01 Mid Section -West Elevation
Scale: 1:20

OUR TOWN HALL PROJECT
PURCELL
Project Office, Room 308, Town Hall, MANCHESTER M60 2LI
+44 (0) 7970 097 432
www.purcelluk.com

PROJECT STATUS	RIBA STAGE 5
CLIENT	MANCHESTER CITY COUNCIL
PROJECT	OUR TOWN HALL
DRAWING TITLE	Albert Memorial Mid Section - West Elevation
SIZE & SCALE	A1: As indicated
DRAWING STATUS	FOR CONSTRUCTION
JOB NUMBER	236959
DRAWING NO.	OTH-PUR-EE-ZZ-DWG-A-7138
REV	02

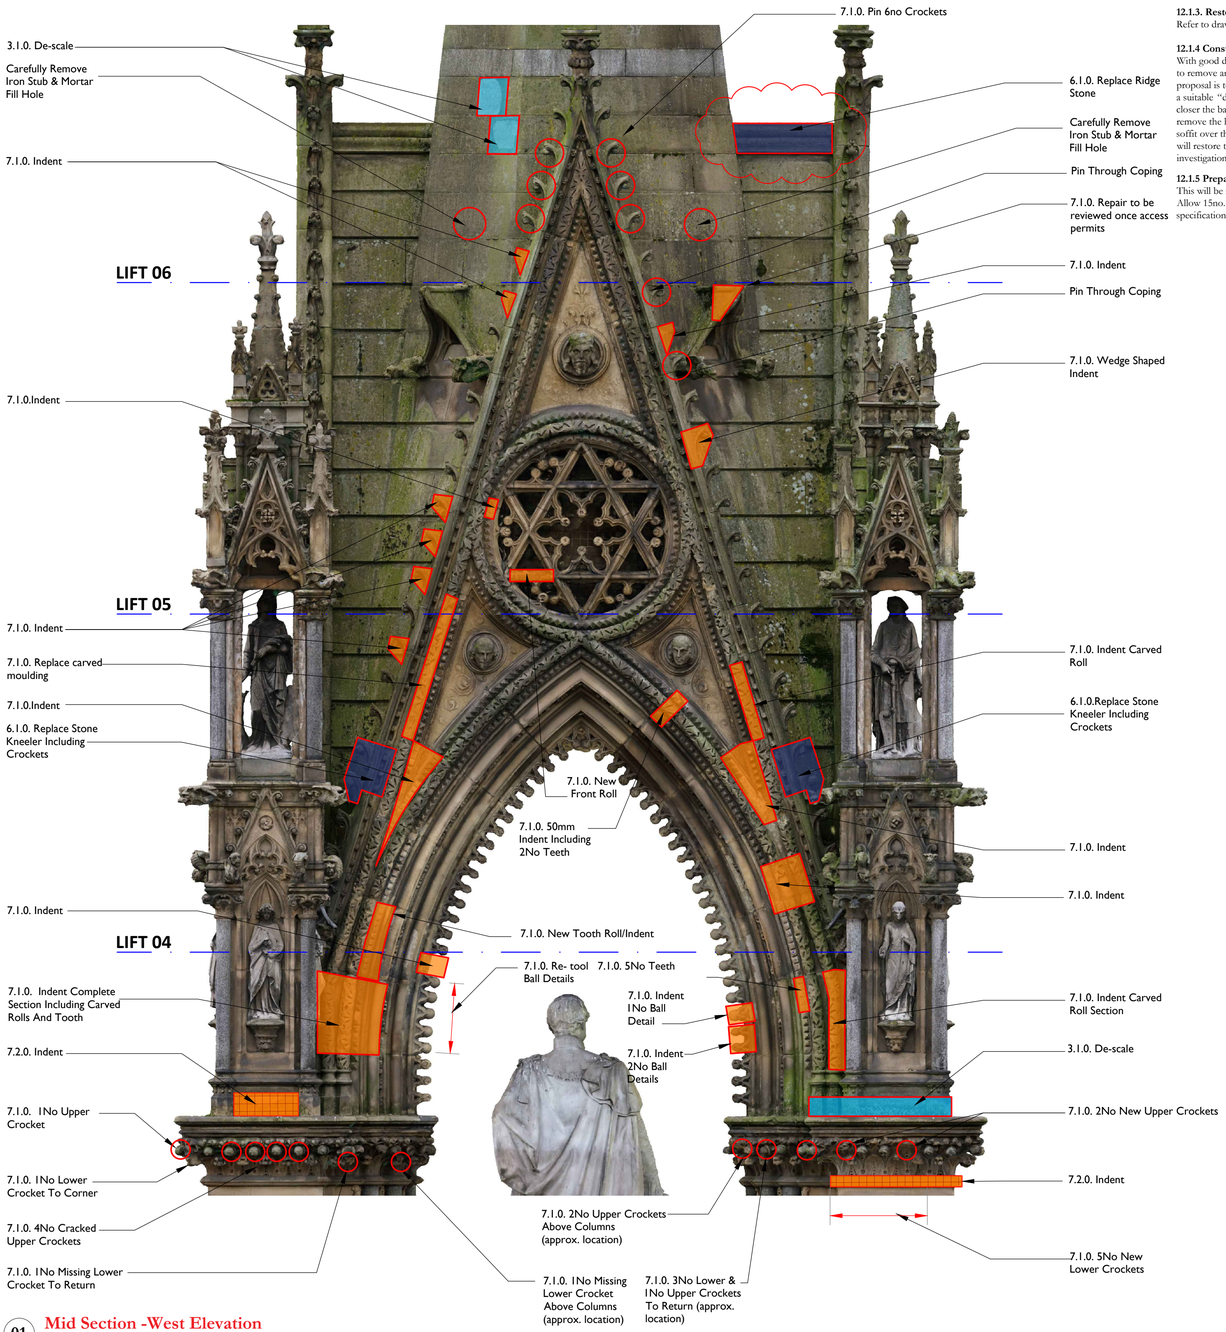
ISSUE	DATE	APPROVED	DRAWN	DESCRIPTION
02	14.08.2024	AD	AB	Confirmation of south gable ridge stone replacement as instructed under LLCL-EWN-003035 (in addition to ridge stone to east gable which has also been replaced)
01	19.05.2023	JC	AB	Ridge stone to south gable to be replaced (in lieu of ridge to east gable)
-	18.03.2022	AB	TJC	First Issue
